Serial No. 10/051,807  
Amendment dated July 13, 2004  
Reply to Office Action of March 30, 2004

**Amendments to the Drawings:**

FIG. 2

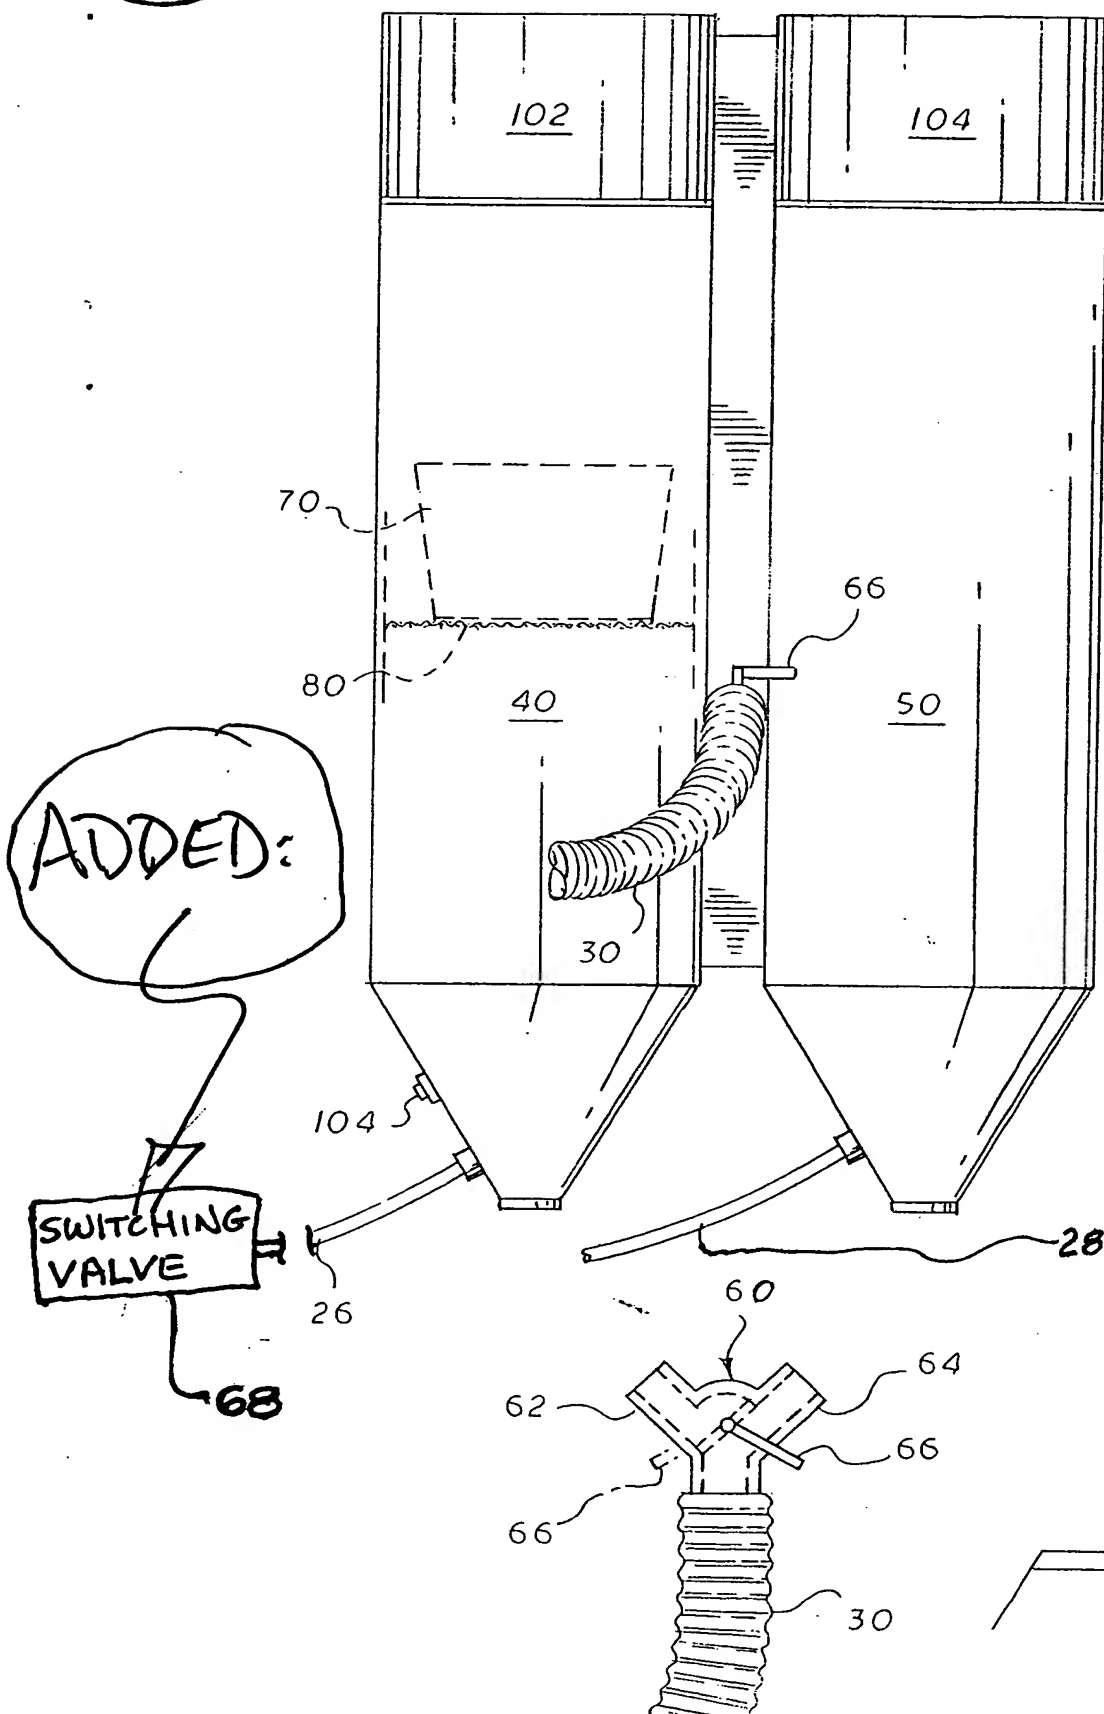
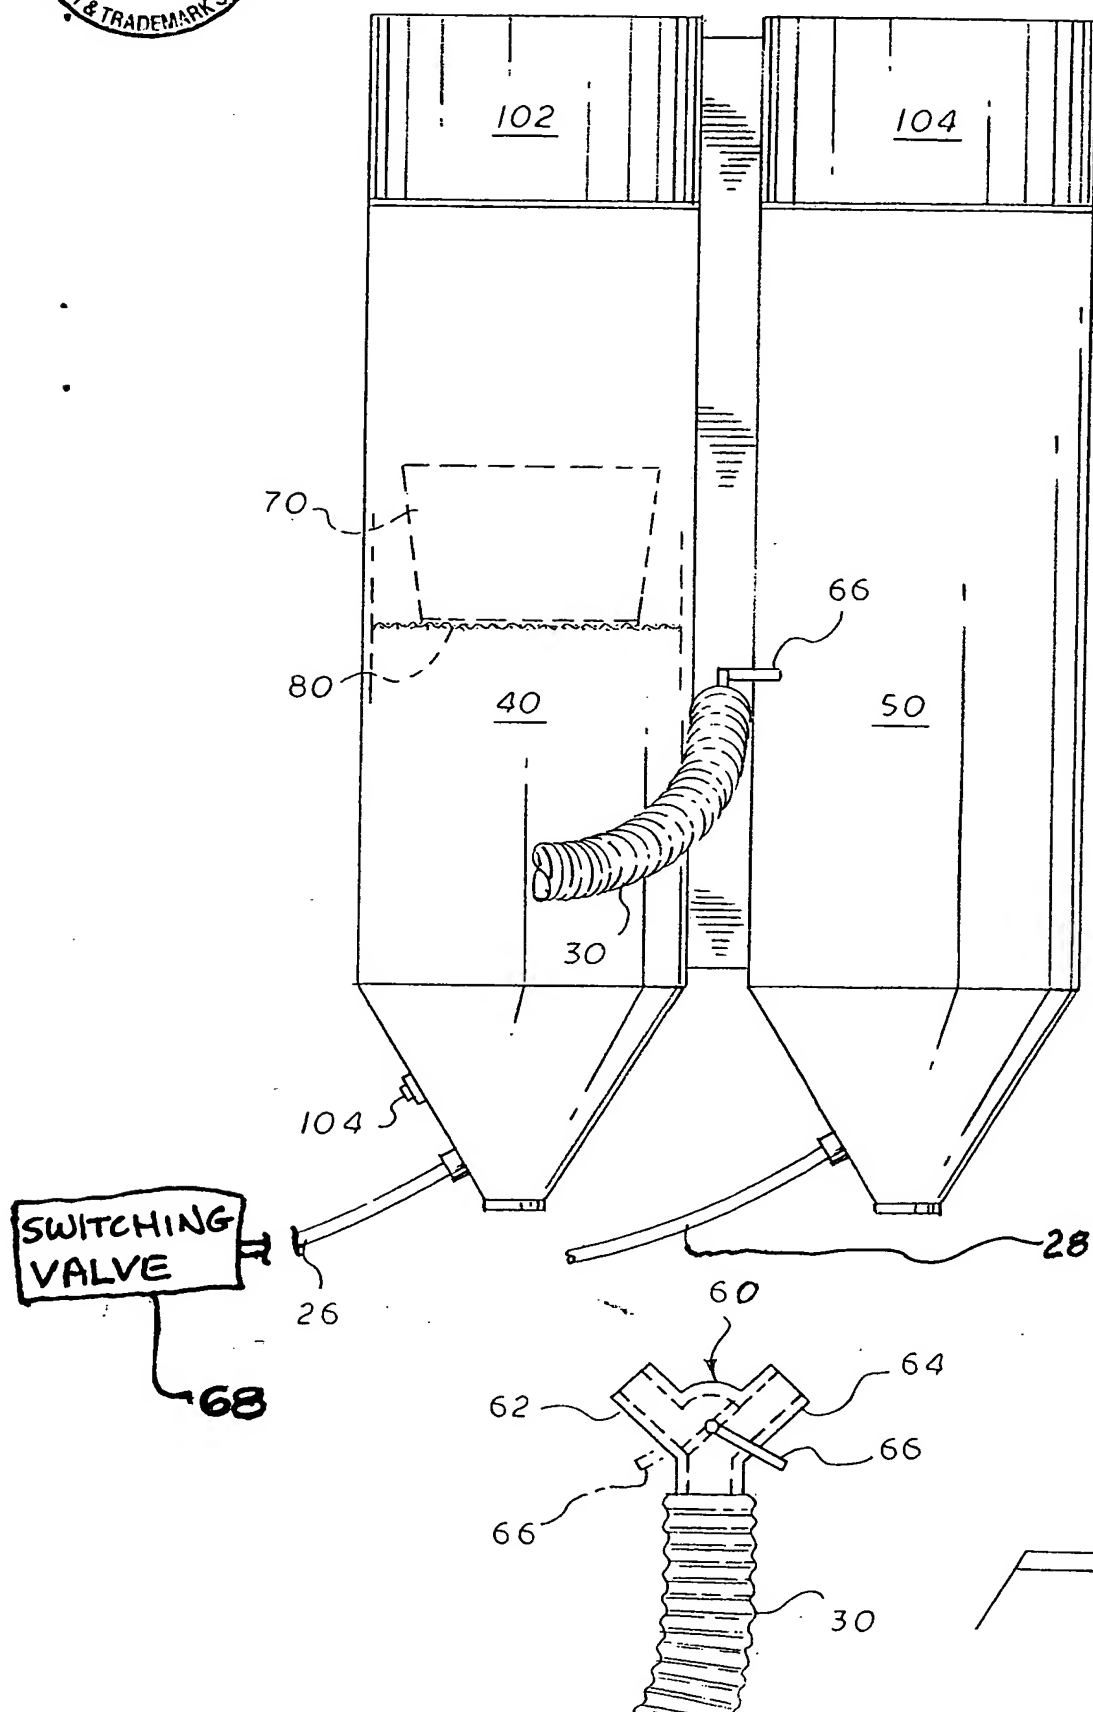
The attached sheet of drawings includes changes to Fig. 2. This sheet, which includes Fig. 2-3, replaces the original sheet including Fig. 2-3. In Figure 2, a block diagram of switching valve 68 has been added.
